# DEVELOPMENT REVIEW COMMITTEE (DRC) COMMENT REPORT

**PROJECT NAME:** Gateway

**CASE NUMBER:** UDP-S23028

**REQUEST:** Site Plan Level III Review: Parking Reduction Request  
for 1,895 Square-Foot Outdoor Seating Area

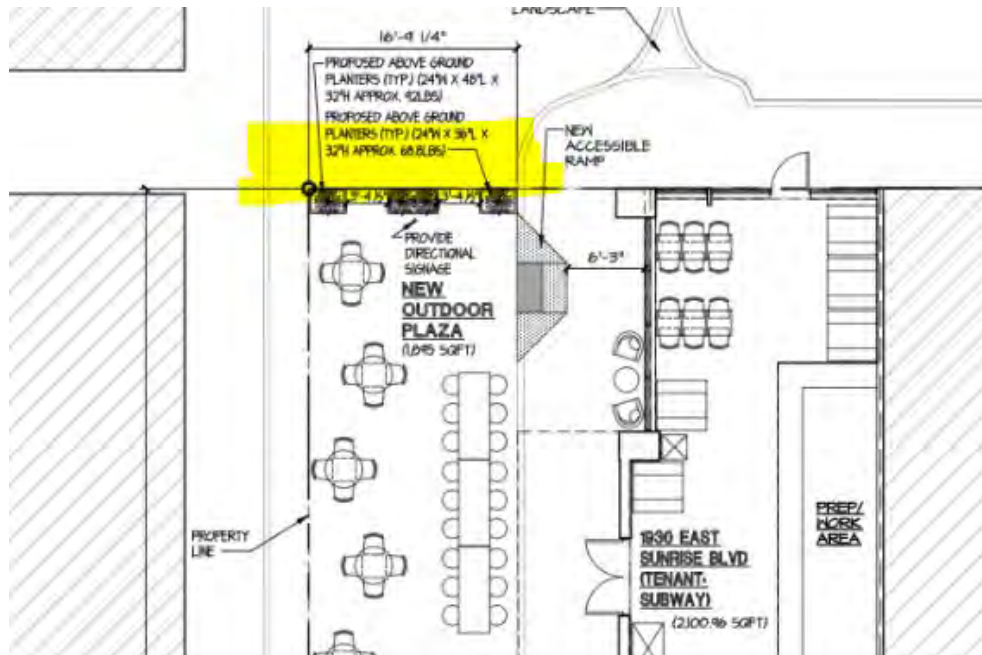
- b. Provide dimensions of the outdoor seating area on the site plan.
  - c. The closure of the entryway requires the continuation of the streetscape, to include a landscape swale, street trees, curb, and sidewalk, etc. Work with Engineering and Landscaping to satisfy the streetscape improvements. Reference the landscaped area in green and sidewalk in yellow, below.
